APPLICATION FOR PERMISSION UNDER SECTION 16 OF THE TOWN PLANNING ORDINANCE (CAP.131)

For Official Use Only 請勿填寫此欄	Application No. 申請編號	A / N7-F7A / 201
	Date Received 收到日期	18 DEC 2020

Hong Kong Chilled Meat & Poultry Association 香港冰鮮家禽業商會

PlanPlus Consultancy Limited

Figure 3.5: Locations and directions of the openings of the Enclosures

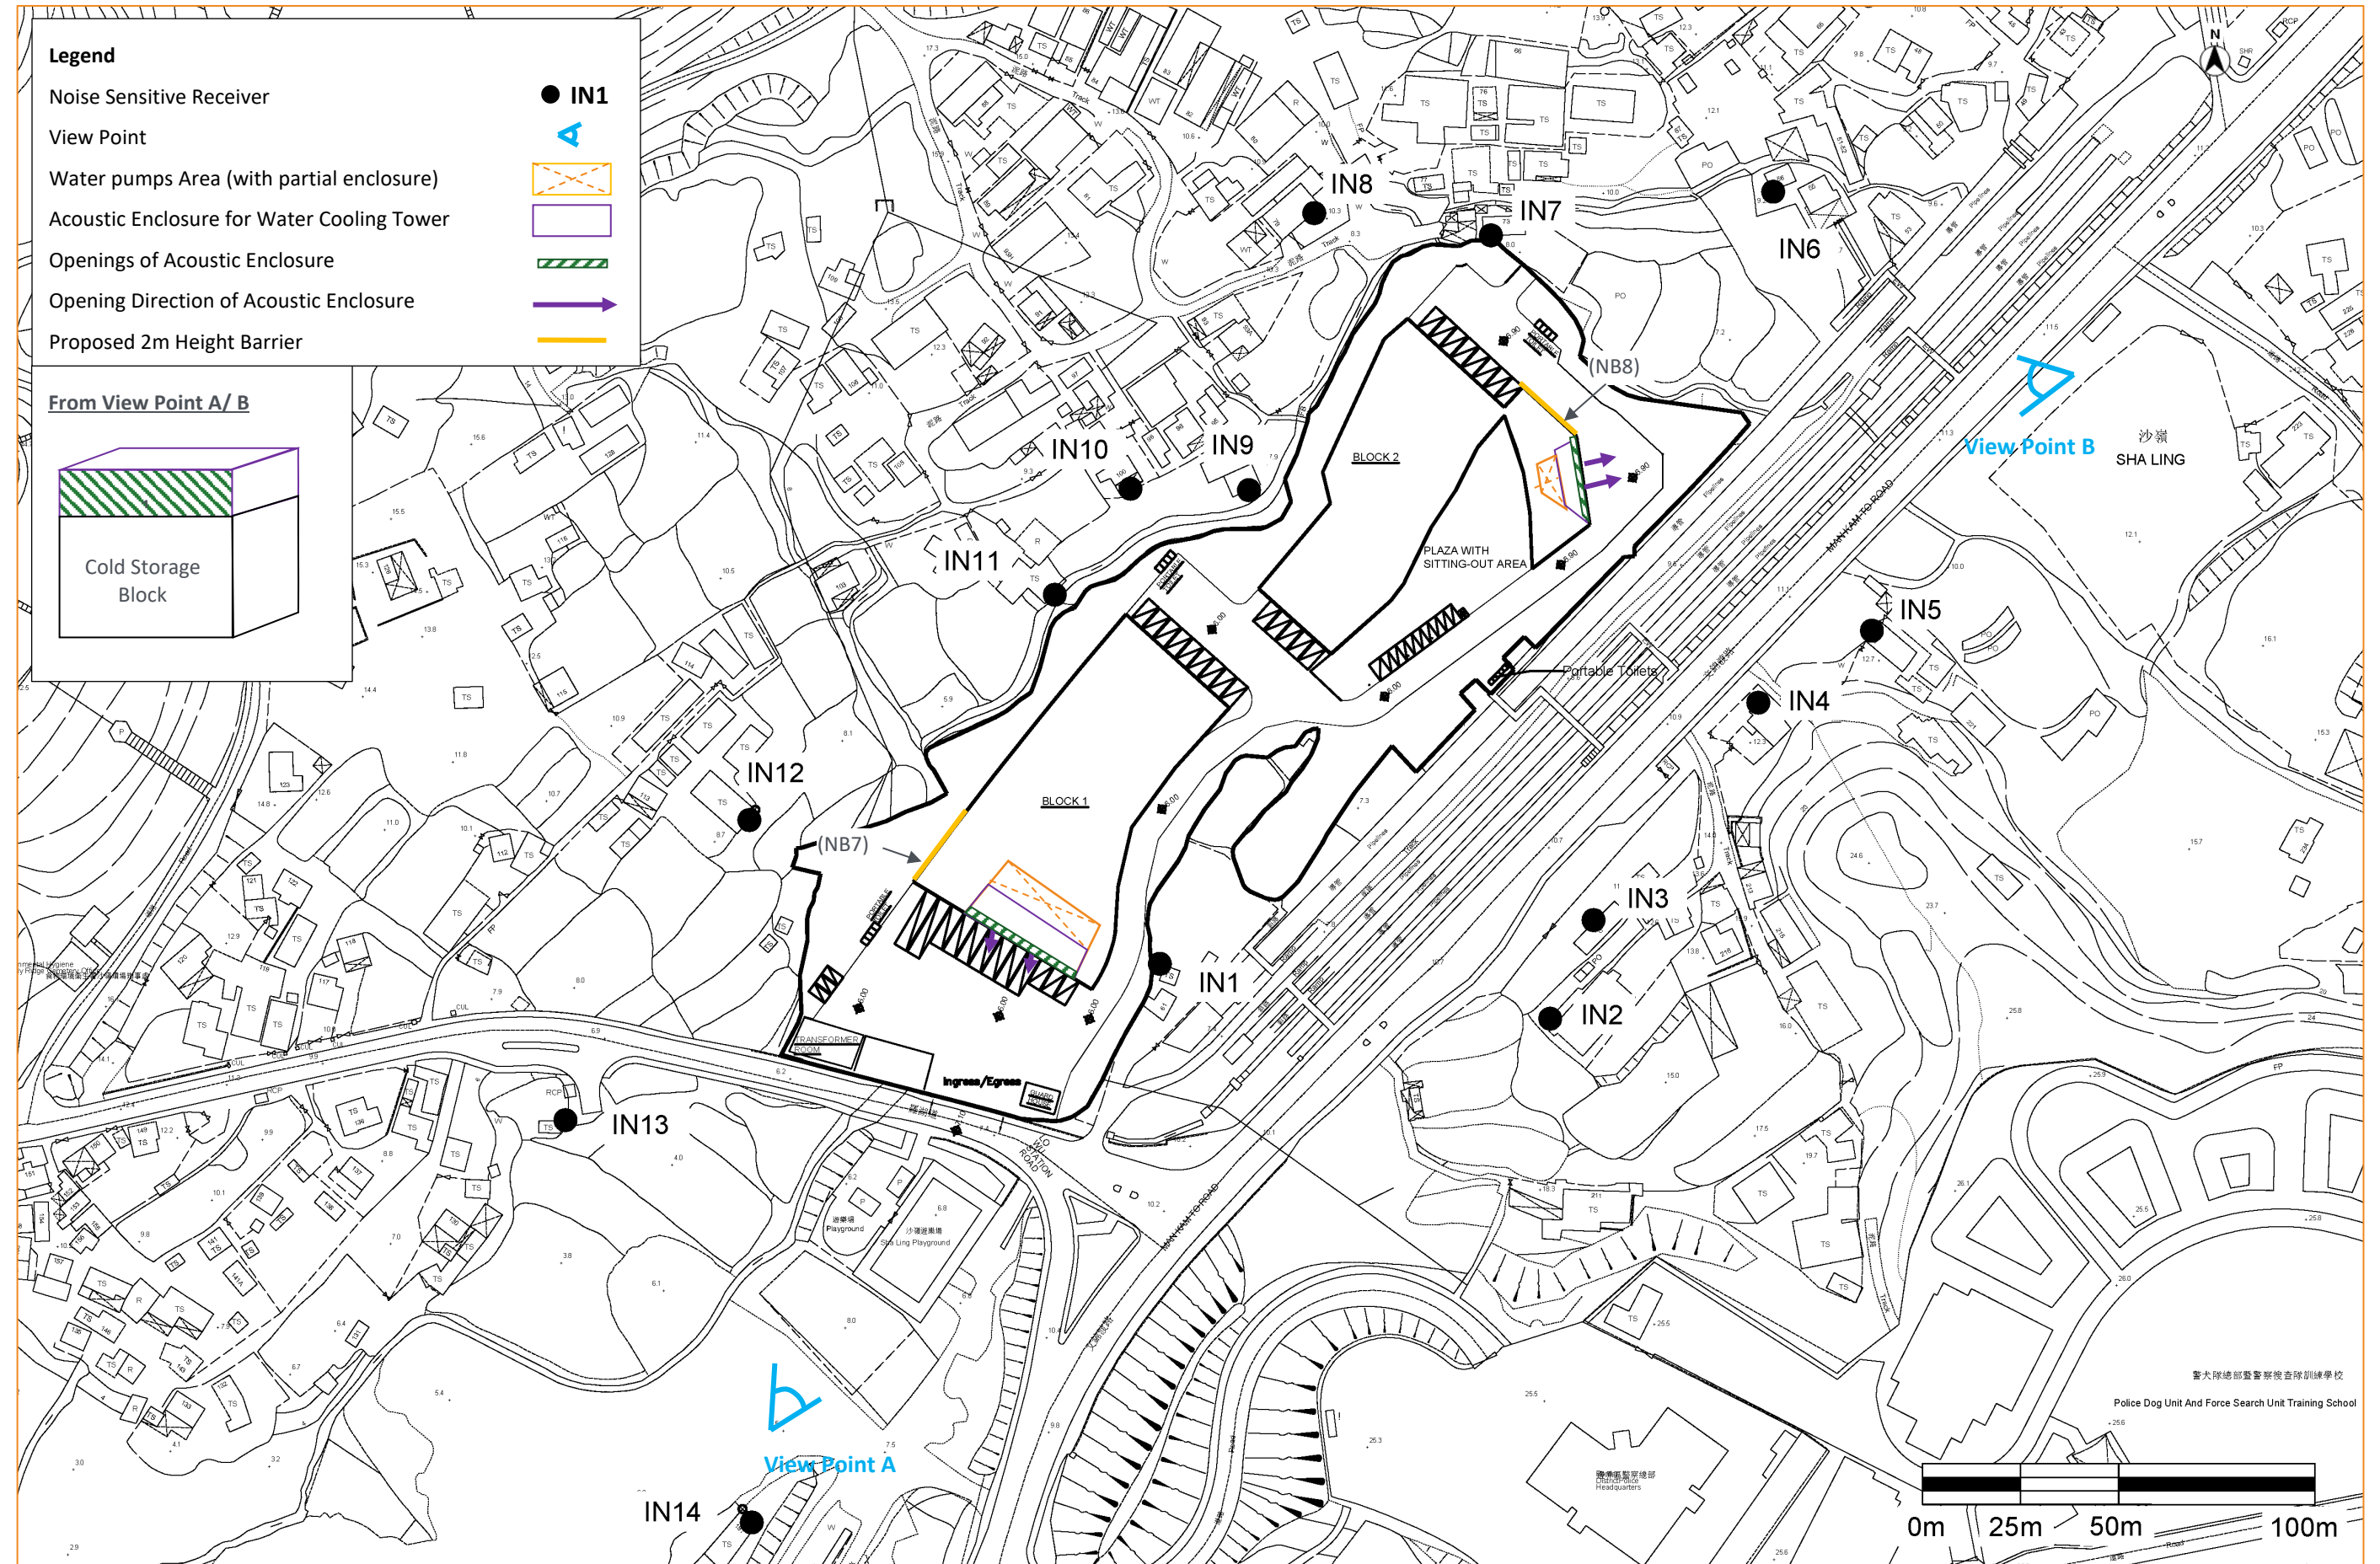
Date	Department	Comments	Responses
		II. Further to item i above, in case the water pumps will be provided with partial enclosure only, please indicate the opening of the enclosure in Figure 3.5.	Full enclosure is proposed for the water pump, while opening of the enclosure of water tower will be indicated in the revised EA report to be submitted during detailed design stage.
		III. The consultant should supplement the design of the enclosure structure in the EA report to justify the use of 20 dB(A) noise reduction.	Noise reduction of 20dB(A) was referred to EPD's Good Practices on Pumping System Noise Control which a noise reduction of up to 30dB(A) can be achieved for a complete enclosure. Nevertheless, the design of noise enclosure and the relevant noise reduction will be provided in the revised EA report to be submitted during detailed design stage.
		IV. Regarding the calculation of fixed noise levels in Appendix G, we have the following comments: A. As shown in Figure 3.5, NSRs IN12, IN13 and IN14 are facing the opening of the semi-enclosure for the water cooling towers at Block 1, while NSRs IN2 to IN5 are facing the opening of the semi-enclosure for the water cooling towers at Block 2. Therefore, the 20 dB(A) noise 6 reduction correction for water cooling towers is not applicable to these NSRs, please review.	The noise enclosure is regarded as an at-source noise mitigation measure. Since the water pumps are proposed to be completely enclosed, 20dB(A) noise reduction to the SWL has been applied for all NSRs in Appendix G. As complete enclosure / complete acoustic enclosure with silencers of water tower with opening was adopted, 10dB(A) of noise reduction will be applied. The appendix will be revised the revised EA report to be submitted during detailed design stage.

N. The distance between the NSRs to the water cooling tower/water pump should be measured from the exact location of the noise sources rather than the geographical centre of the enclosure structures as shown in Figure 3.5.	The tentative locations of the noise sources were adopted in the calculation and indicated in Figure 3.5. Appendix G will be amended based on the detailed design of M&E plants in the revised EA report to be submitted during detailed design stage.
		<u>Traffic Noise Impact</u> 26. Section 3.4 – According to Section 1.3 and the planning statement, a junction improvement work is proposed at the junction of Man Kam To Road and Lo Wu Station Road. However, the traffic noise impact associated with the junction improvement work has not been addressed in the EA report, please supplement.	As shown on Figures 2.3 and 2.4 of the TIA Report enclosed in Annex 5 of the Planning Statement, the junction improvement works mentioned in para. 1.3.1 of the EA Report will include provision of road markings and revolving warning lights at the Site Entrance of the Proposed Development on Lo Wu Station Road, and provision of restriction mark on Man Kam To Road.

- 3.3.43 They are distributed on the roof top of Cold Storage Blocks 1 and 2. Two (2) water cooling towers and three (3) water pumps are located on Cold Storage Block 1, while one (1) water-cooling tower and two (2) water pumps located on Block 2, as shown on **Figure 3.5**.

- 3.3.48 In order to further minimise the noise impact, it is suggested that the openings of enclosure of Block 1 should face to Sha Ling Playground, while the openings of enclosure of Block 2 should face to Man Kam To Road as shown on **Figure 3.5**.

Figure 4.2: Decking over the Existing Watercourse (Operation during Heavy Raining)

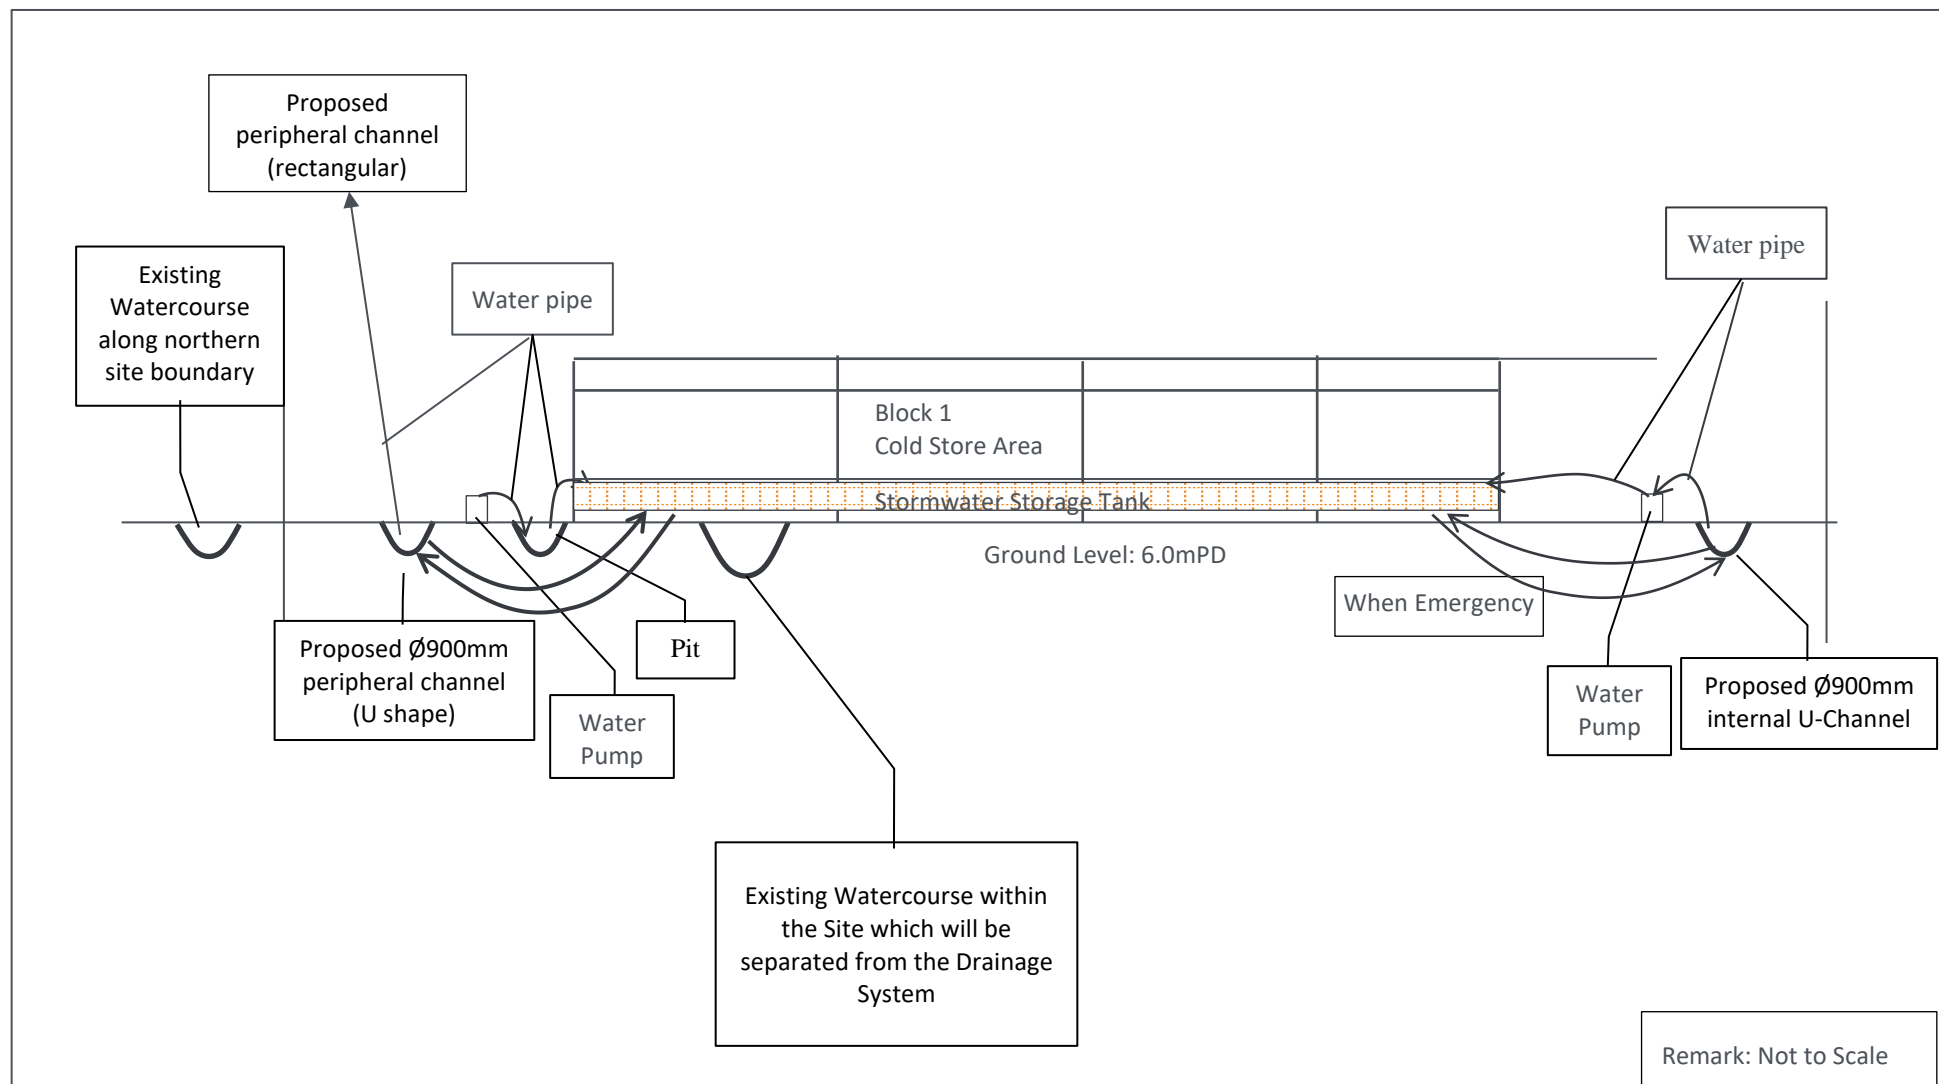
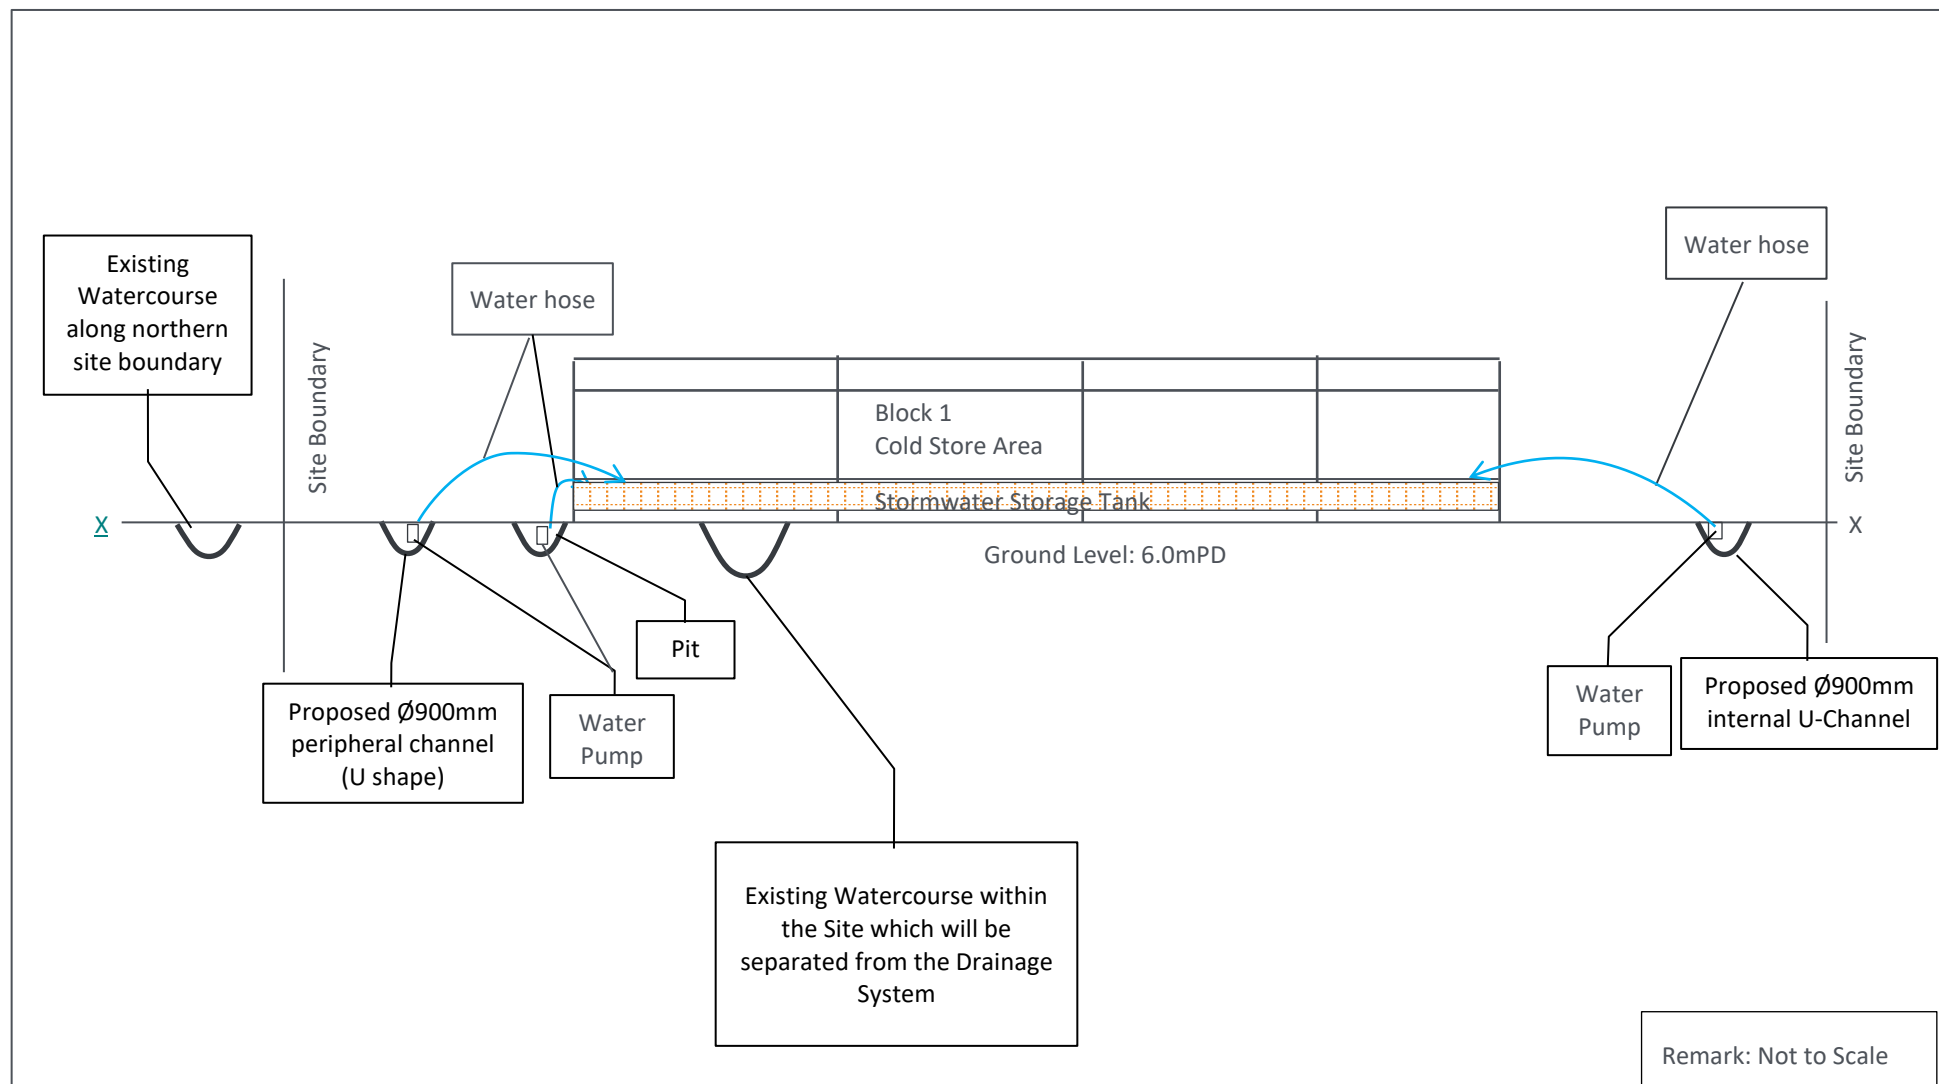
38.Section 4.3.11 - Any figure to show decking of watercourse?	For the EA Report, Figure 4.2 and Section 4.4.11 have been added to show the decking of the watercourse.

4. Figure 4.2 -	
		(a) We note that the "Proposed peripheral channel (rectangular)" is indicated as water pipe (red circles above). Please clarify.	The text box has been removed and Figure 4.2 has been revised.

(f) Figure 4.3 seems contradicting with Figure 4.2, as Figure 4.2 states that both channels pump water to the stormwater storage tank, and Figure 4.3 states that only the southern u-channel does. Please clarify if both u-channels are pumped to stormwater storage tank, and how is that discharged at the river.	Stormwater from both proposed channels will be pumped to the stormwater storage tank. Please refer to the revised Figure 4.2 and the new Figure 4.3.

(g) Please show the section line of Figure 4.2.	The X-X Section line has been shown on the revised Figure 4.2 and the new Figure 4.3. In addition, the X-X section line has also been indicated on the revised Figure 4.4 and the new Figure 4.5 respectively.

10. S.4.4.10, S.4.5.11, Figure 4.2- Please clarify “... when emergency...”	Paras. 4.4.10 and 4.5.11 have been revised that only small amount of stored stormwater surplus will be discharged into proposed channels after heavy raining. The words “when emergency” have therefore been deleted from paras. 4.4.10 and 4.5.11, and Figure 4.2.

- 4.4.16 The existing watercourse will be decked over underneath the proposed development as shown in **Figure 4.2**. A Drainage Impact Assessment ("DIA") for the Centre has been carried out and is presented in a separate DIA report appended to the Planning Statement. The DIA has concluded that the surface runoff induced by the Centre would not cause any adverse drainage impact on the existing downstream watercourse with the provision of the proposed internal drainage system and aboveground stormwater storage tank.
